SERVICE BULLETIN
REVISION TRANSMITTAL SHEET

MODEL BD-100-1A10 (CH-300)

Service Bulletin No.	100-25-35		
Date of Basic Issue	Nov 15/2012		
Revision No.	01	Dated	Sep 23/2013
Revision No.	02	Dated	Jan 11/2016

MODIFICATION – BAGGAGE COMPARTMENT – MODIFICATION TO THE LH & RH BAGGAGE BAY HEATER INSTALLATIONS AND REACTIVATION OF THE LH BAGGAGE BAY HEATER AFTER MODIFICATION AND RE-IDENTIFICATION AS PART NO. 3436-07

Figure 1 – Heater Mat Modification/Re-Identification

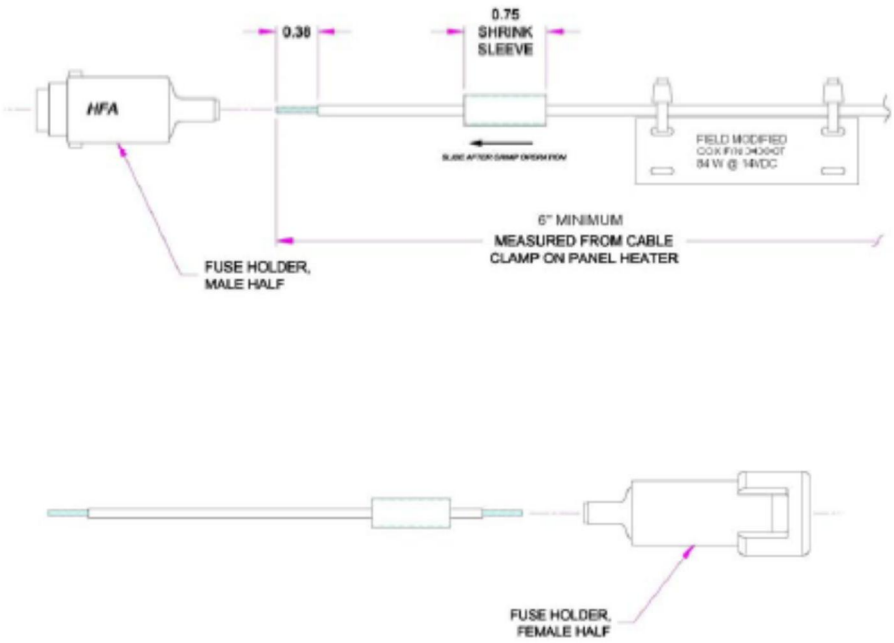
(7) For aircraft, Serial No. **20003** to **20364**, **20366**, **20367**, **20369** and **20372**, do the modification to the heater mat Part No. 3436-06-1/0 as follows: Refer to Figure 1.

(a) Disconnect the heater’s two power leads (14 AWG White wires) from the TM415 pin “D” and pin “E”.

(b) Select one of the two 14 AWG leads (White) from the heater mat and cut it minimum 6 in (15.24 cm) from the clamp on the heater mat and keep the cut section for later installation.

(k) Insert the fuse, Part No. MDA-8-R, in one of the fuse holder halves, assemble the two fuse holder halves together and twist to tighten.

(l) Attach the “FIELD MODIFIED” label Part No. 3436-172, that identifies the heater mat as Part No. 3436-07 to the lead wire with two cable ties, Part No. MS3367-4-9.

(n) After completion of the heater mat modification, measure the resistance across the two lead wires. The resistance should be within the following range: 2.12 to 2.59 Ω.

Figure 2

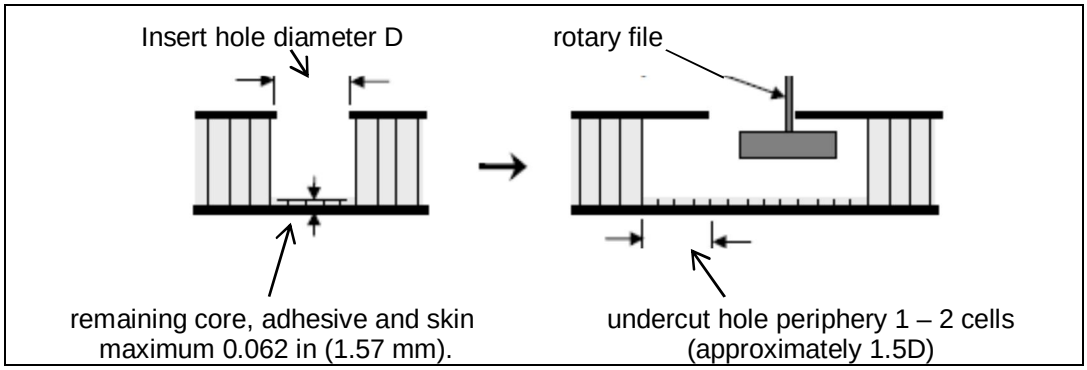
(5) Use a counter bore to drill the holes, 0.452 to 0.457 in (11.48 to 11.60 mm) in diameter in the sidewall panel, but do not drill all the way to the other layer. Refer to Figure 2.

(6) With an appropriate rotary file, undercut the sandwich panel core to increase the potting cavity diameter to approximately 1.5 times the diameter of the insert hole. Refer to Figure 2.
